WORKSHOP AGENDA

Planning Commission

April 16, 2024 @ 5:30 PM

Item Title: Site Plan - UHAUL, Phase 2 - Two (2) Buildings Totaling Approximately 43,000 Square Feet on 10 Acres. Requested by SEC, Inc. Property located at 503 New Paul Road (Tax Map 17, Parcel 40.03). I-2 (Heavy Industrial) Zoning District. Property owned by Amerco Real Estate Co. **(WITHDRAWN)**

Utility Plan

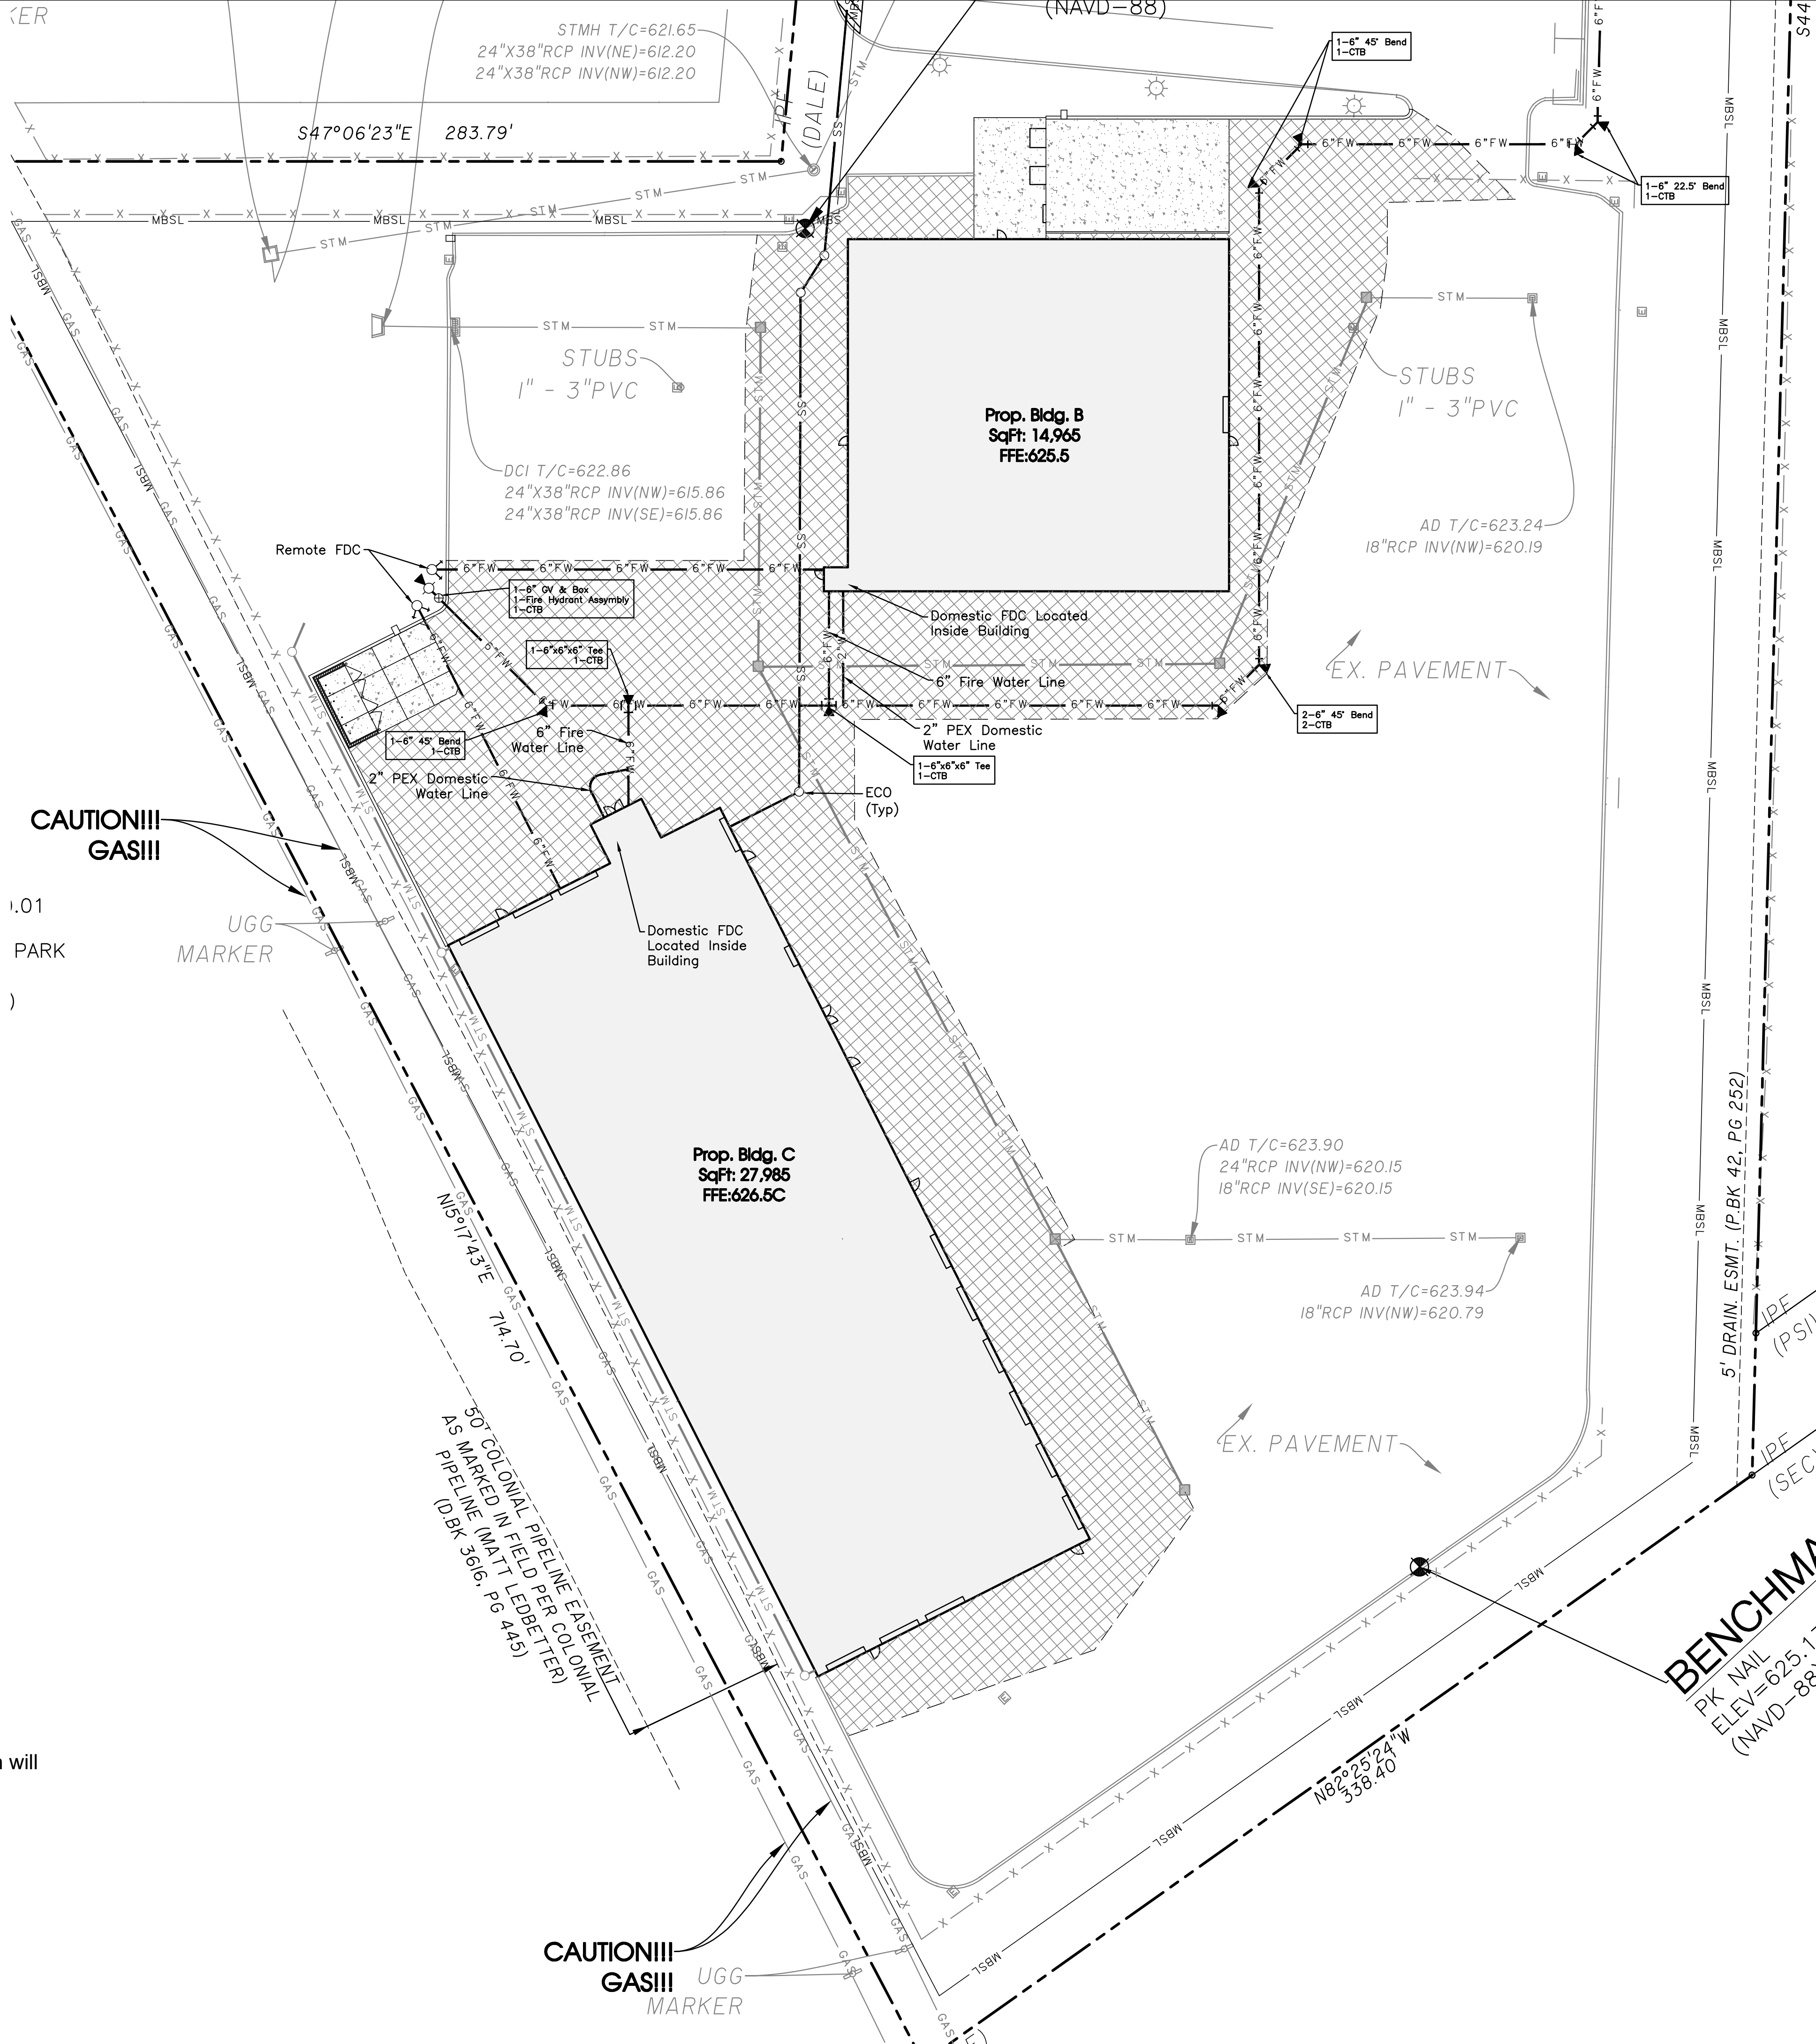
1. (For information) Sht C2.2: 2-way Fire Dept. Connection Detail – Per previous discussions with City Fire Marshall, the City wants a single 5" Storz connection. Detail provided graphically shows a Siamese connection. Please make this clear to avoid confusion.

3. (For Information) Sht C2.2: Fire Line Notes: Note 2 states "200 Pound Pressure Test." I believe the requirement was reduced to 150 psi test as part of NFPA 25, 2014, but please verify requirement with Fire Marshall, Curtis Brinkley.

4. (For information--to be provided for building permit) Sht C2.2: Please point to the location of the fire sprinkler riser inside each building and refer to a detail. Draw the detail. It should include but not be limited to the following:

SITE PLAN

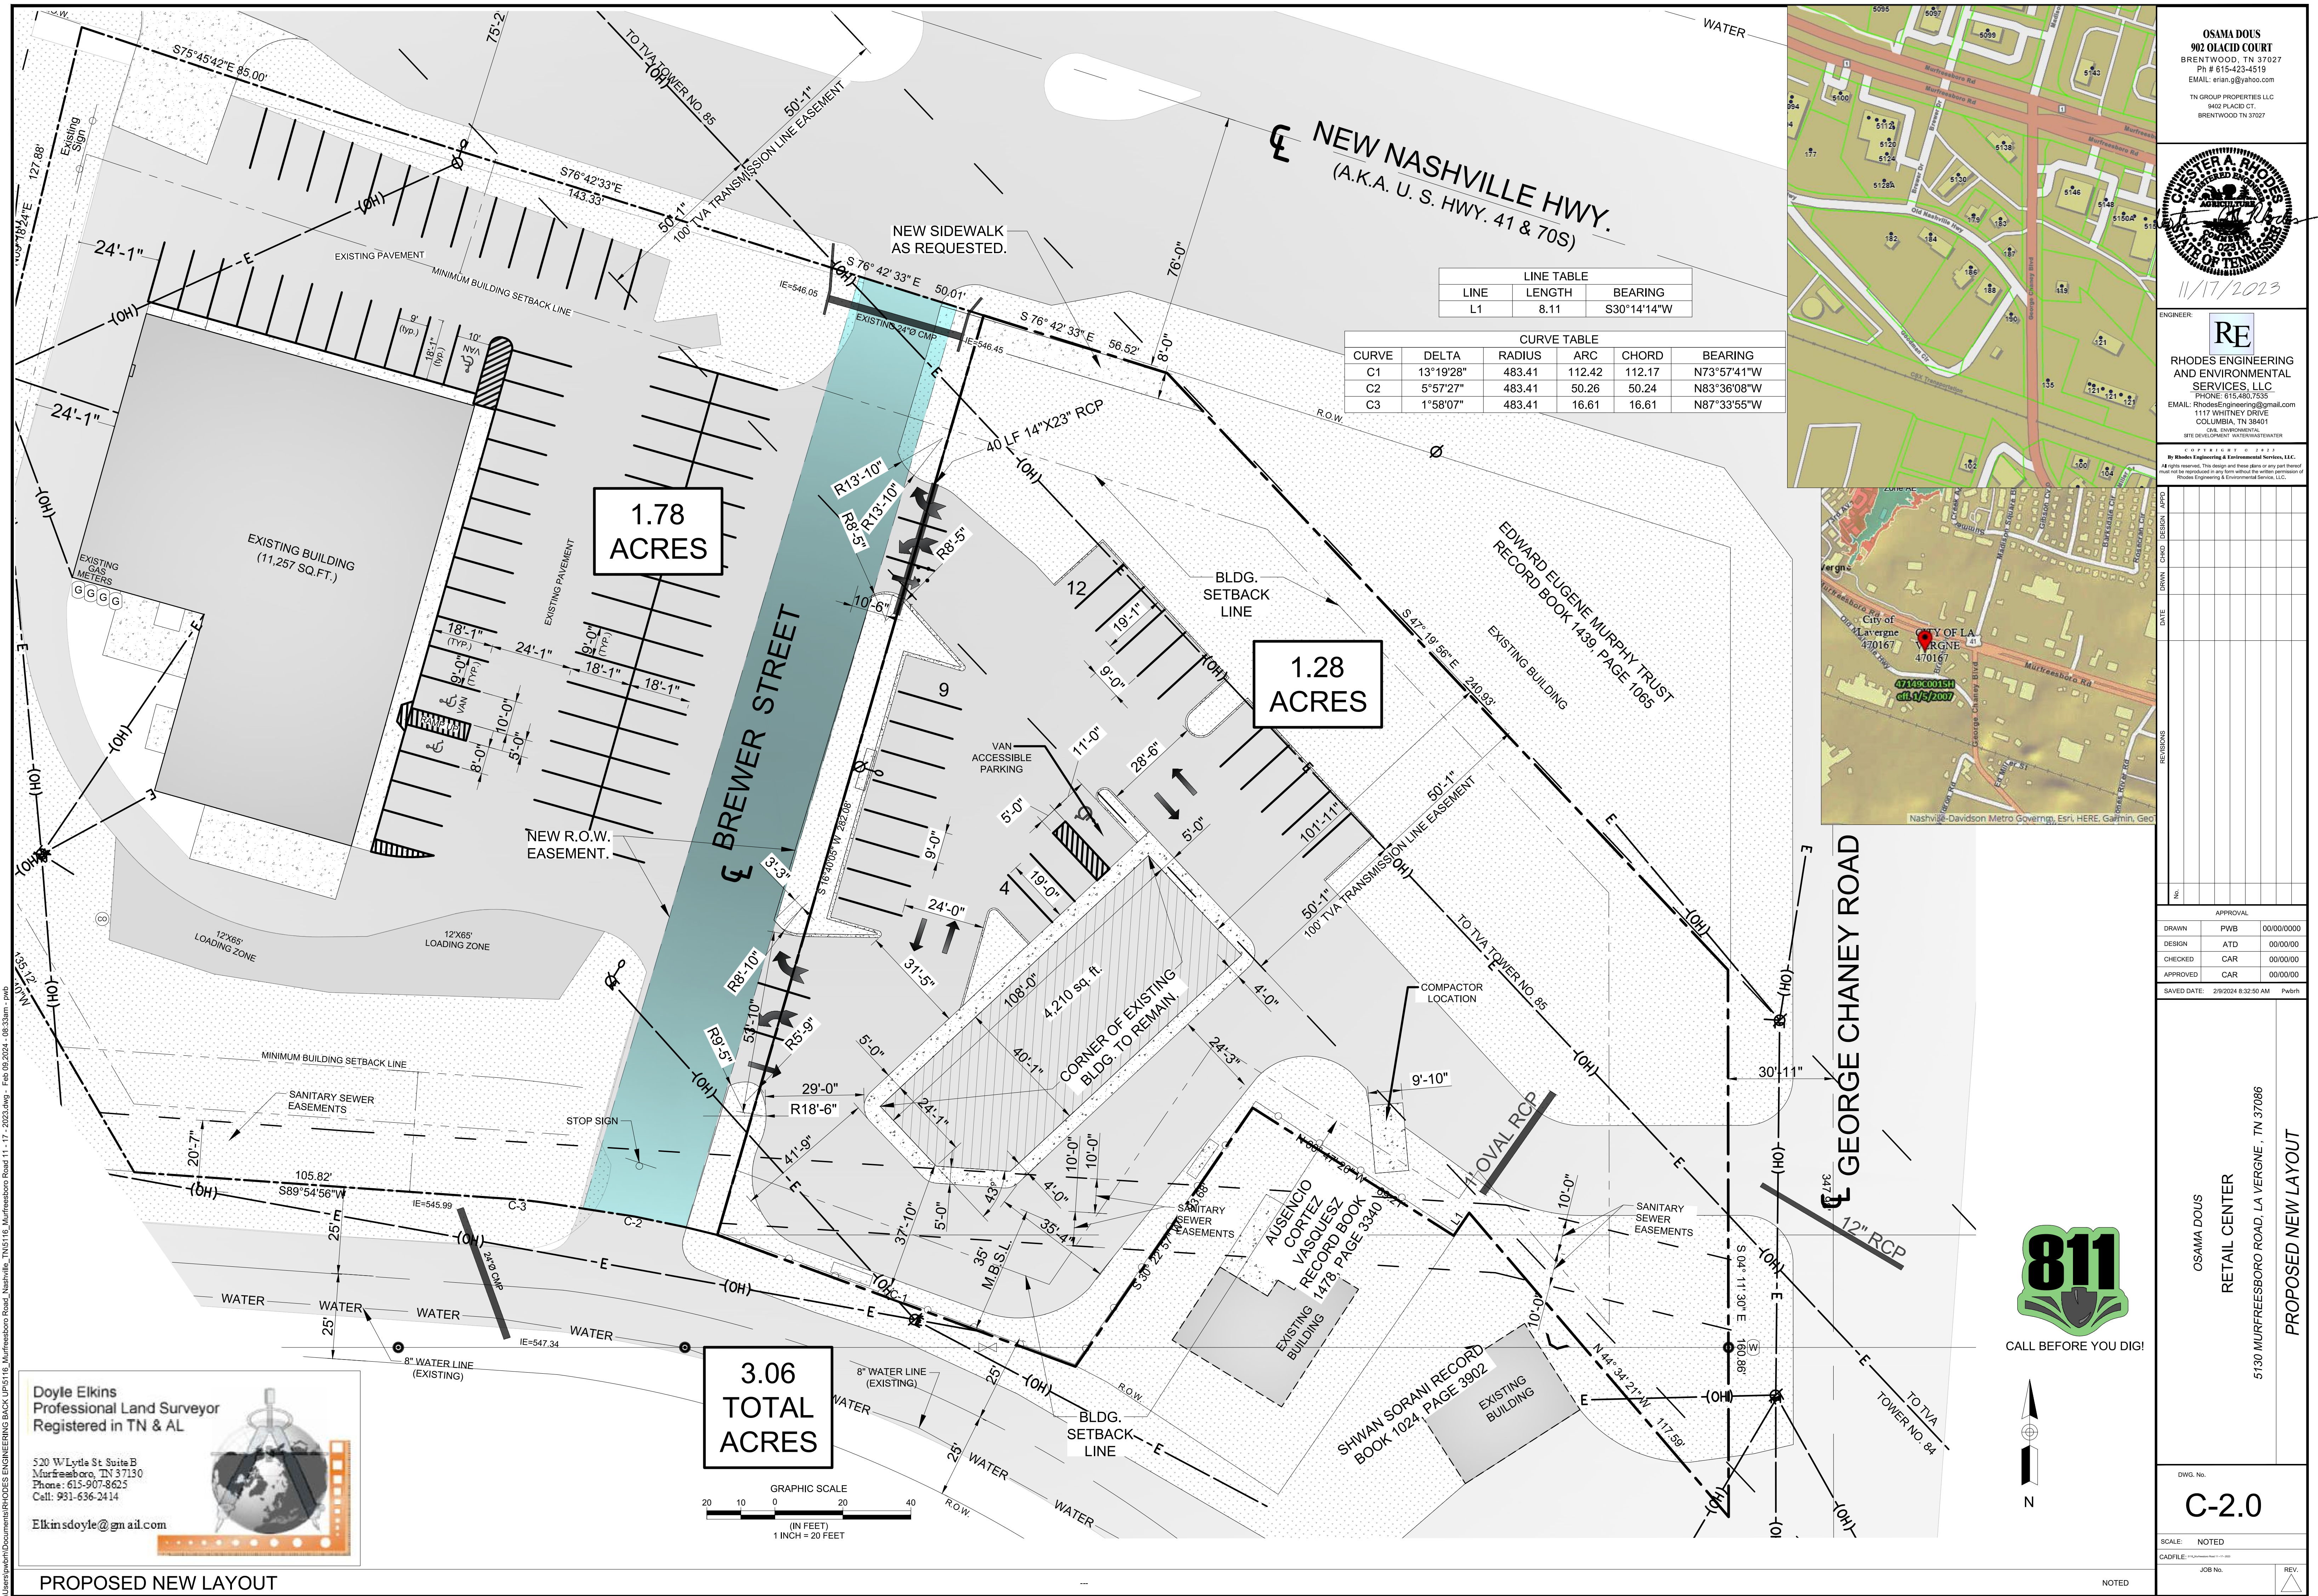
1. Provide a grading and drainage plan showing how site run-off will be handled for the modified structure. Staff does not concur with engineer's statement on Sheet C-2.1 that no grading plan is required. The architectural plans show doorways exiting from the proposed portion of the building which will require existing and proposed elevations to confirm IBC and ADA access requirements are met.

4. (Sheet C-2.1) Provide total driveway widths at the northern drive onto Brewer Street and the drive onto George Chaney Road. Correct the driveway width shown at the south entrance to Brewer Street.

5. (Sheet C-2.1) The dumpster screen is proposed to be exposed CMU with a wooden gate. The Planning Commission will review that proposal against requirements of the Murfreesboro Road Overlay District.
